Site Instruction

SI 24

PROJECT : Hampton Manor
PROJECT No : 1136.13
DATE : August 14, 2018

Title: Removal of Insulation behind Precast

1:20 A601

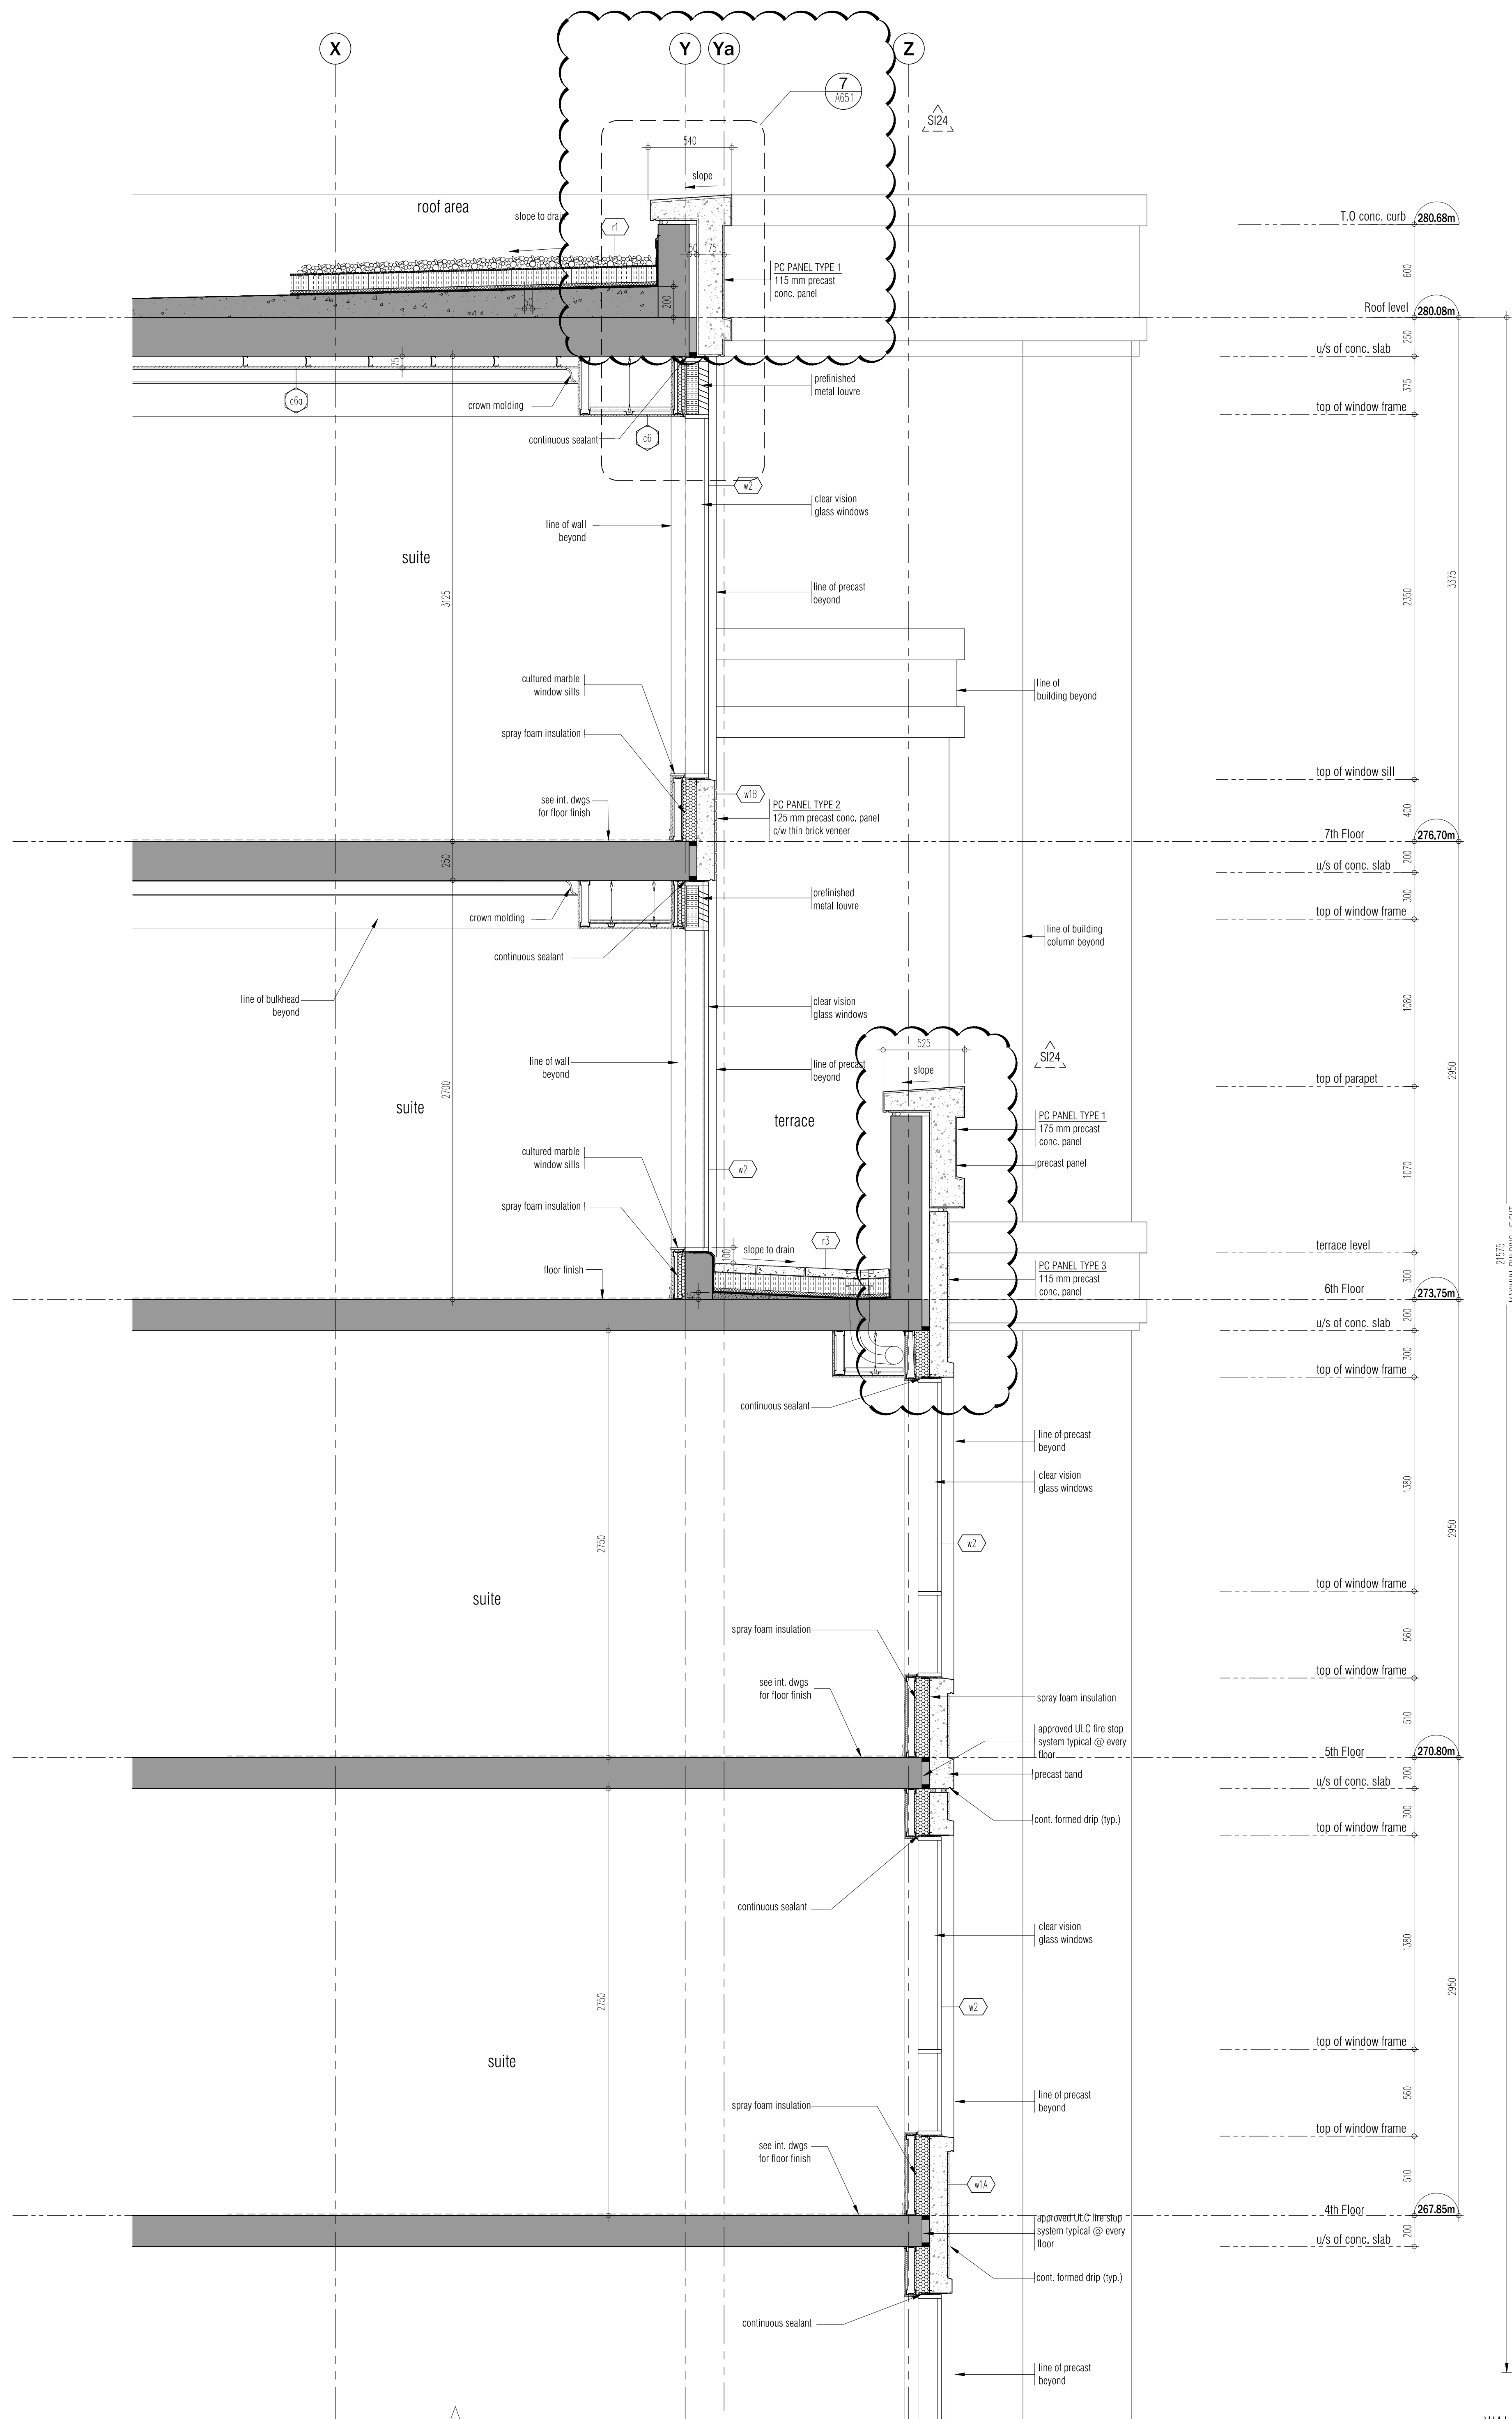
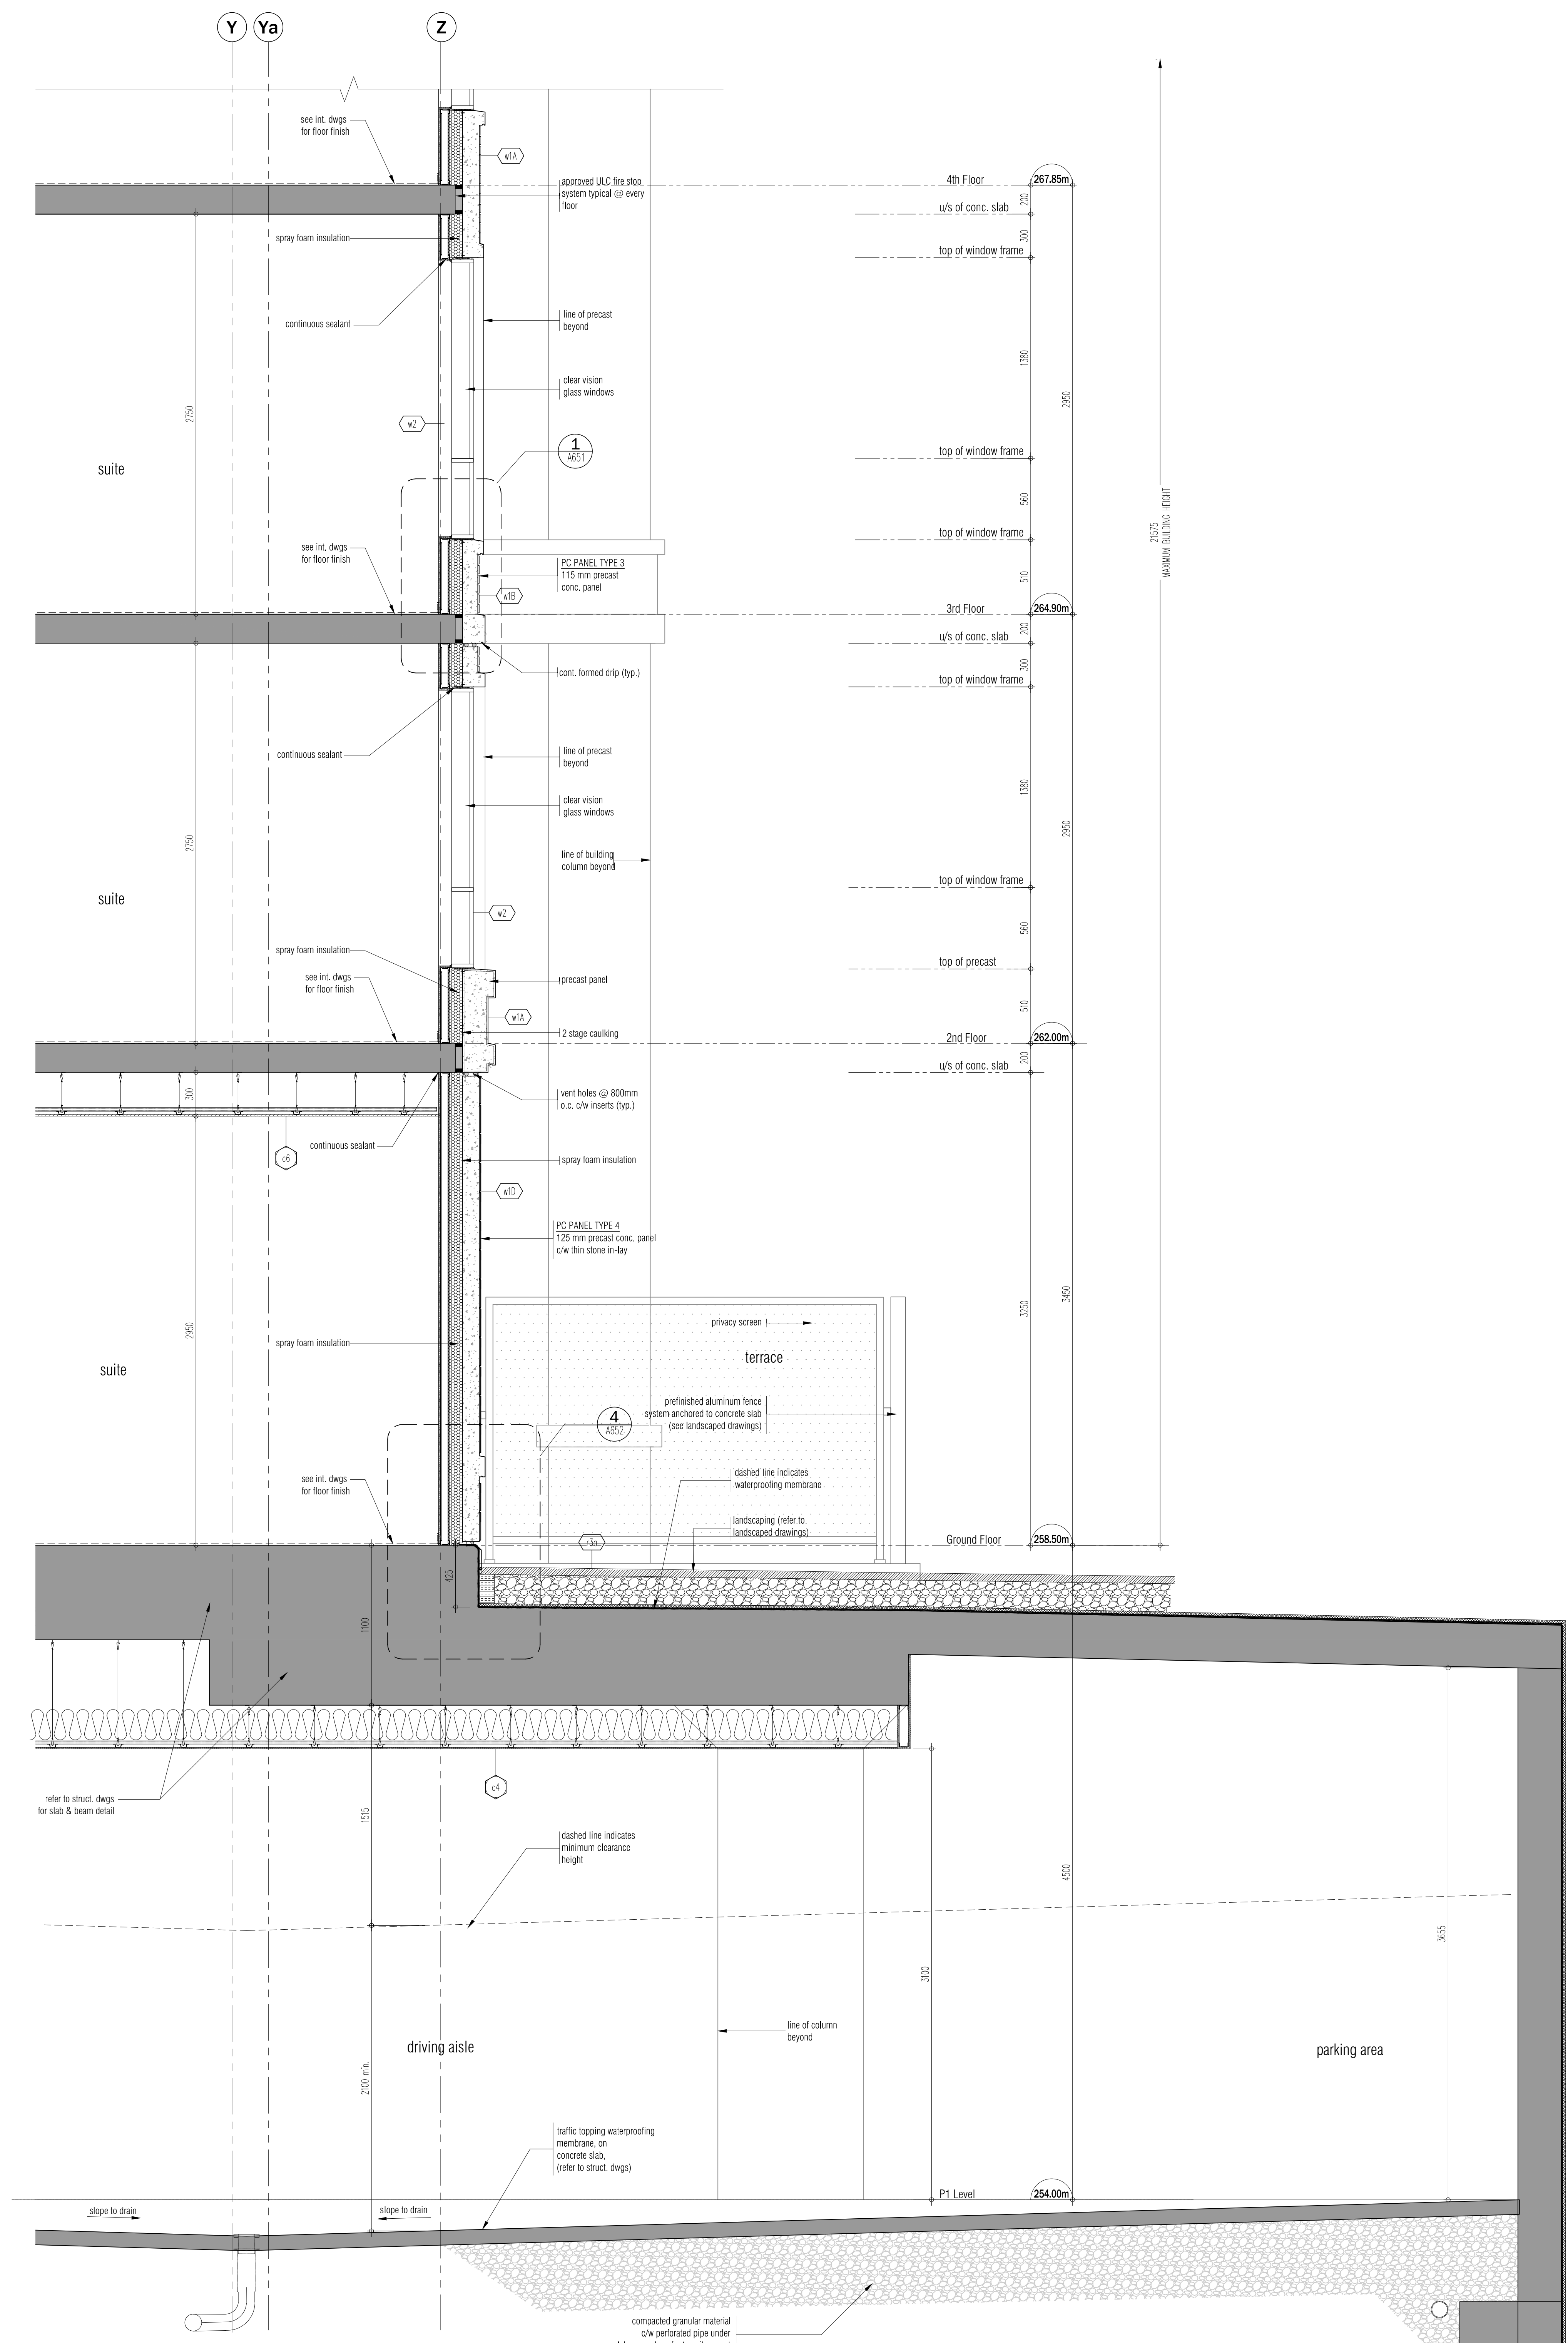
- Removal of insulation behind precast at terraces and roof.
